ROAD SAFETY AUDIT

DETAILED DESIGN STAGE

Wetheron Road, Wetheron

Bon Accord Bridge Upgrade and Approach Works

Figure 5: Delineation on bridge at 16 September 2024

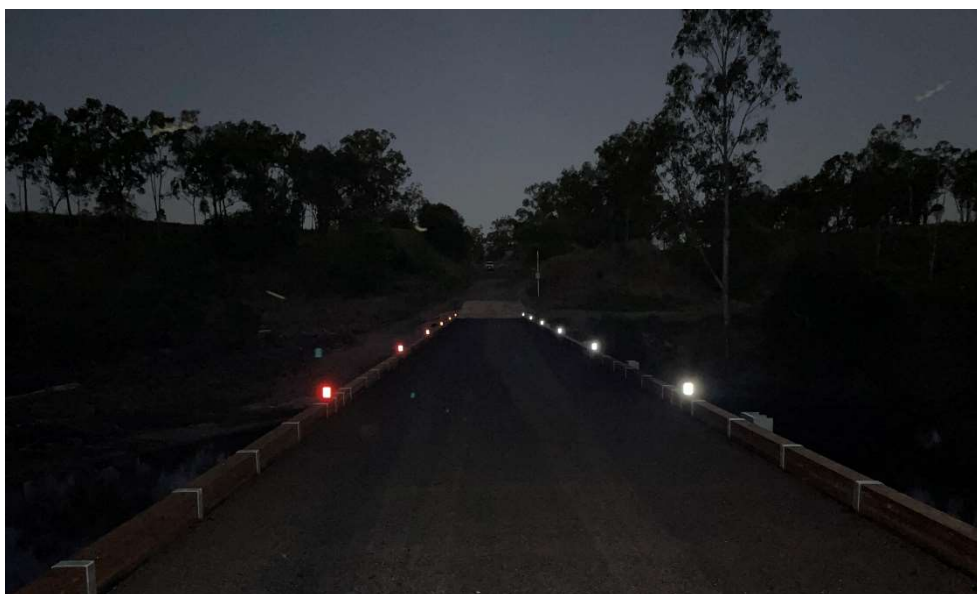
The design drawings do not indicate the installation of guideposts as part of the project. The approaches to the bridge has insufficient guideposts to delineate the edge of the roadway to help guide motorists, especially at night. Poor delineation increases the risk of motorist failing to identify the road geometry and increasing the risk of loss of control, run off road and head on type crashes.

- Consider the installation of guidepost on the approach curves to the bridge in accordance with AS 1742.2:2022 MUTCD Part 2.
- Consider reduced spacing of guideposts due to known fogs in the area.
- Consider the installation of RRPM's on linemarking on the bridge to improve nighttime delineation of the roadway.

Clause No.	Audit Findings	Risk Level	Audit Recommendations	Project Manager Accept: Yes or No	Design RPEQ Reasons / Comments
9.2.1	<p>Guide Posts</p> <p>The design drawings do not indicate the installation of guideposts as part of the project. The approaches to the bridge has insufficient guideposts to delineate the edge of the roadway to help guide motorists, especially at night. Poor delineation increases the risk of motorist failing to identify the road geometry and increasing the risk of loss of control, run off road and head on type crashes.</p>	<p>Risk Ranking: High</p> <p><i>Risk Ranking Decision Process:</i> <i>Frequency: Unlikely</i> <i>Severity: Serious</i> <i>Risk: High.</i></p>	<p>Suggested Actions</p> <ul style="list-style-type: none"> - Consider the installation of guidepost on the approach curves to the bridge in accordance with AS 1742.2:2022 MUTCD Part 2. - Consider reduced spacing of guideposts due to known fogs in the area. - Consider the installation of RRPM’s on linemarking on the bridge to improve nighttime delineation of the roadway. 	<p>Comments noted, CRC to amend plans to address suggested actions recommended.</p>	<p>Notation or specification to be included in project documentation. BoQ issued with IFC calls for REGPs. Revised IFC drawing will detail</p>

Figure 7: Existing and New Signage

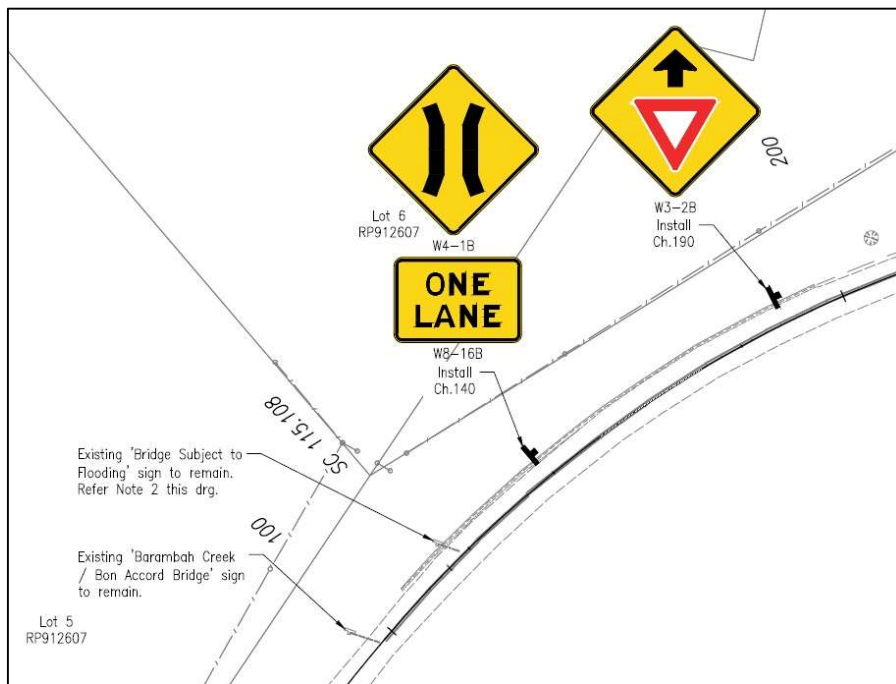
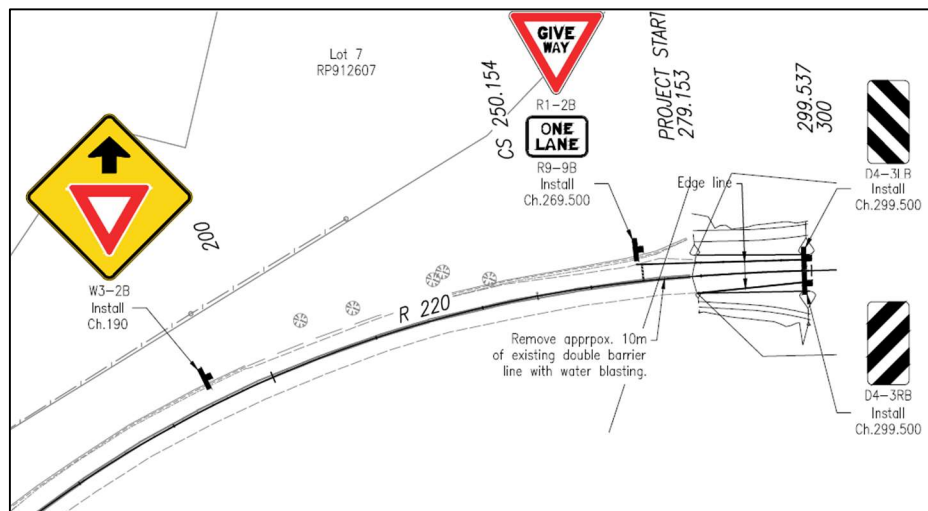
The design drawings show existing signage that is to remain and new signage to be installed on the western approach to the bridge. This signage is insufficiently spaced (refer figure 6 below). The “Give Way Ahead” sign has been positioned at the absolute minimum separation to the give way sign. The approach to the give way is on a 10% down grade and will require greater stopping distance (refer figure 7 below). This increases the risk of motorists being unable to comprehend all signage information and result in overshooting the giveaway and crashing head on with oncoming traffic on the single lane bridge.

- Consider providing sufficient separation between all signage on the approaches to the bridge.
- Consider providing a greater separation between the “Give Way Ahead” and “Give Way” signs to provided sufficient time for motorist to comprehend and react on the 10% decline.

Clause No.	Audit Findings	Risk Level	Audit Recommendations	Project Manager Accept: Yes or No	Design RPEQ Reasons / Comments
9.2.4	<p>Signage Spacing</p> <p>The design drawings show existing signage that is to remain and new signage to be installed on the western approach to the bridge. This signage is insufficiently spaced. The “Give Way Ahead” sign has been positioned at the absolute minimum separation to the give way sign. The approach to the give way is on a 10% down grade and will require greater stopping distance. This increases the risk of motorists being unable to comprehend all signage information and result in overshooting the give way and crashing head on with oncoming traffic on the single lane bridge.</p>	<p><u>Risk Ranking: High</u></p> <p><u>Risk Ranking Decision Process:</u> <i>Frequency: Unlikely</i> <i>Severity: Serious</i> <i>Risk: High.</i></p>	<p>Suggested Actions</p> <ul style="list-style-type: none"> - Consider providing sufficient separation between all signage on the approaches to the bridge. - Consider providing a greater separation between the “Give Way Ahead” and “Give Way” signs to provided sufficient time for motorist to comprehend and react on the 10% decline. 	<p>Comments noted, CRC to amend plans to address suggested actions recommended.</p>	<p>W3-2 signage was positioned at the absolute minimum required distance. If preferred these can be moved further out and the IFC to be updated to reflect this preference.</p>

Figure 10: Cross Section with Proposed New Kerbing

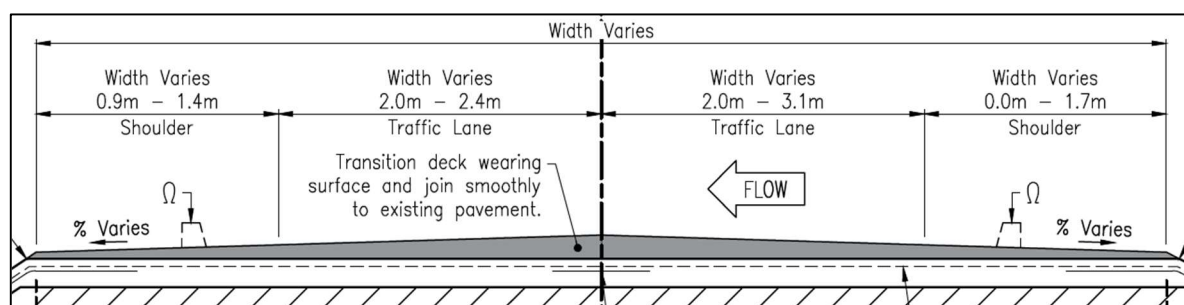
The typical cross sections show proposed new kerbing on the approach to the new bridge. The location shown is positioned in the middle of the road shoulder. The proposed location is not detailed anywhere else within the drawing set. If the new kerbing is to be introduced mid shoulder, there is a risk that motorists could strike the end of the kerb increasing the risk of loss of control crashes.

- Consider updating plans to detail full kerb setout.
- Consider introducing kerbing at the edge of the sealed formation and transitioning down to the bridge kerb width.

9.3 Hazards					
9.3.1	Kerb The typical cross sections show proposed new kerbing on the approach to the new bridge. The location shown is positioned in the middle of the road shoulder. The proposed location is not detailed anywhere else within the drawing set. If the new kerbing is to be introduced mid shoulder, there is a risk that motorists could strike the end of the kerb increasing the risk of loss of control crashes.	Risk Ranking: High Risk Ranking Decision Process: <i>Frequency: Unlikely</i> <i>Severity: Serious</i> <i>Risk: High.</i>	Suggested Actions - Consider updating plans to detail full kerb setout. - Consider introducing kerbing at the edge of the sealed formation and transitioning down to the bridge kerb width.	Comments noted, CRC to amend plans to address suggested actions recommended.	To be included in an updated IFC drawings due to bridge positioning of bridge detailed design IFC altering.

Figure 12: Feathering of Deck Wearing Surface

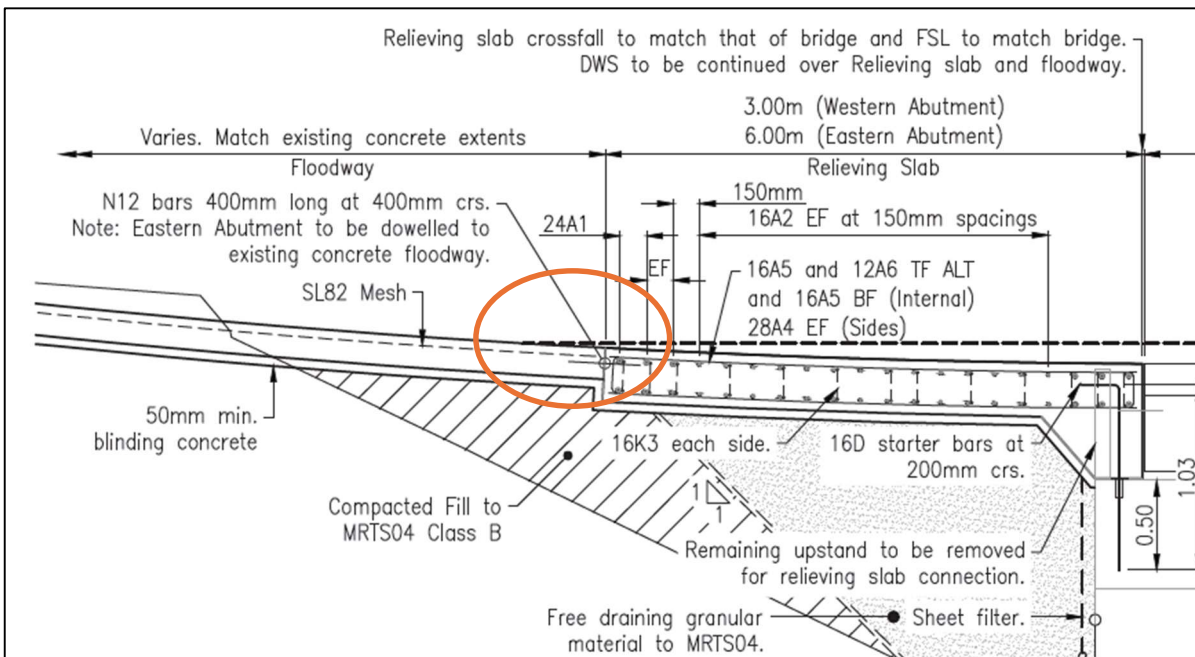
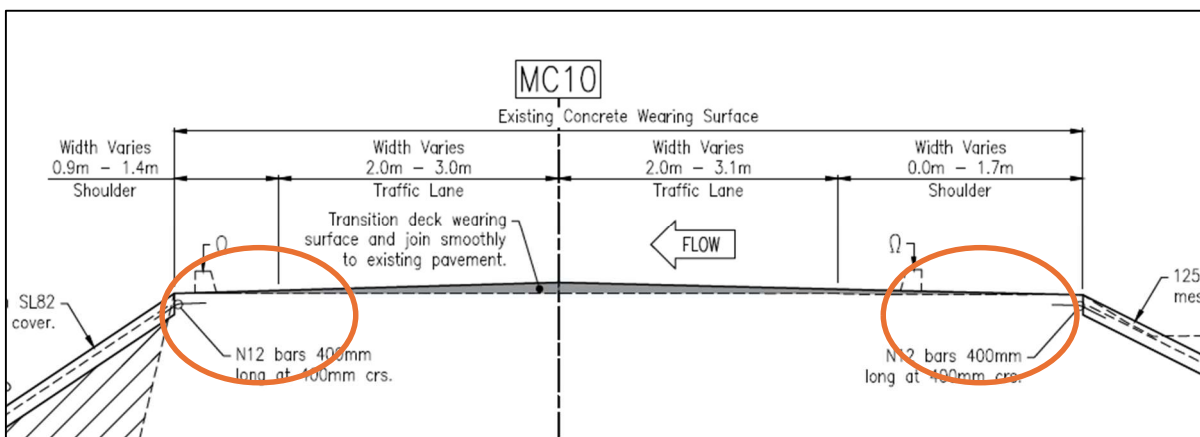
The design proposes to transition and feather out the new bridge deck wearing surface to the approach concrete slabs. Deck wearing surfaces need to be laid to a minimum thickness and cannot be feathered out to a zero thickness. If placed as shown within the design drawings, there is a risk that the wearing surface could delaminate from the concrete approaches during flood events resulting in a rough road surface, increasing the risk of loss of control crashes.

- Consider keying the deck wearing surface into the concrete approaches, or
- Consider amending the road grading on the approaches to the concrete slabs to allow for a minimum thickness wearing surface layer to be applied over the concrete approaches to the bridge, or
- Consider constructing the approach concrete slabs flush to the new bridge relieving slab profile with minimum depth deck wearing surface.

9.4 Constructability					
9.4.1	Deck Wearing Surface The design proposes to transition and feather out the new bridge deck wearing surface to the approach concrete slabs. Deck wearing surfaces need to be laid to a minimum thickness and cannot be feathered out to a zero thickness. If placed as shown within the design	Risk Ranking: High Risk Ranking Decision Process: <i>Frequency: Unlikely</i> <i>Severity: Serious</i> <i>Risk: High.</i>	Suggested Actions - Consider keying the deck wearing surface into the concrete approaches, or - Consider amending the road grading on the approaches to the concrete slabs to allow for a	Comments noted, CRC to amend plans to address suggested actions recommended. Note; the approaches to match bridge DWS levels, therefore avoiding feathering of AC.	Preference was for the new approach and relieving slab to match to DWS, but construction sequencing proposed at the time (bridge in after) restricts ability to match well. It is understood that

Clause No.	Audit Findings	Risk Level	Audit Recommendations	Project Manager Accept: Yes or No	Design RPEQ Reasons / Comments
	drawings, there is a risk that the wearing surface could delaminate from the concrete approaches during flood events resulting in a rough road surface, increasing the risk of loss of control crashes.		minimum thickness wearing surface layer to be applied over the concrete approaches to the bridge, or - Consider constructing the approach concrete slabs flush to the new bridge relieving slab profile with minimum depth deck wearing surface.		there has since been further modification to the bridge positioning due to the existing abutment ledge height and now concrete relieving slab can match DWS. IFC to be updated to reflect

Figure 14: Cross Section at Start of Project

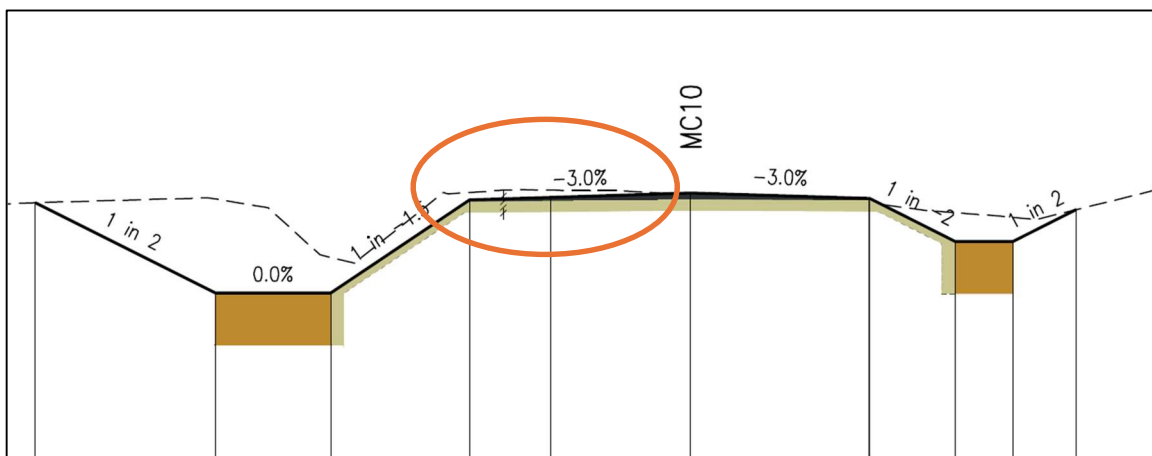
The design cross sections show that the new design profile does not match the existing road shape at the start of the project. If the new construction matches the design plans there will be a rough connection to the existing roadway at the start of the project that increases the risk of loss of control crashes.

- Ensure that smooth connections are provided between existing and new work.
- Ensure that design standards are adhered to for rotations of road crossfall to match at tie in locations.

9.4.2	Cross Section Profile at Start of Project The design cross sections show that the new design profile does not match the existing road shape at the start of the project. If the new construction matches the design plans there will be a rough connection to the existing roadway at the start of the project that increases the risk of loss of control crashes.	<u>Risk Ranking: High</u> <i>Risk Ranking Decision Process:</i> <i>Frequency: Unlikely</i> <i>Severity: Serious</i> <i>Risk: High.</i>	Suggested Actions - Ensure that smooth connections are provided between existing and new work. - Ensure that design standards are adhered to for rotations of road crossfall to match at tie in locations.	Comments noted, CRC to amend plans to address suggested actions recommended.	To be amended in revised IFC
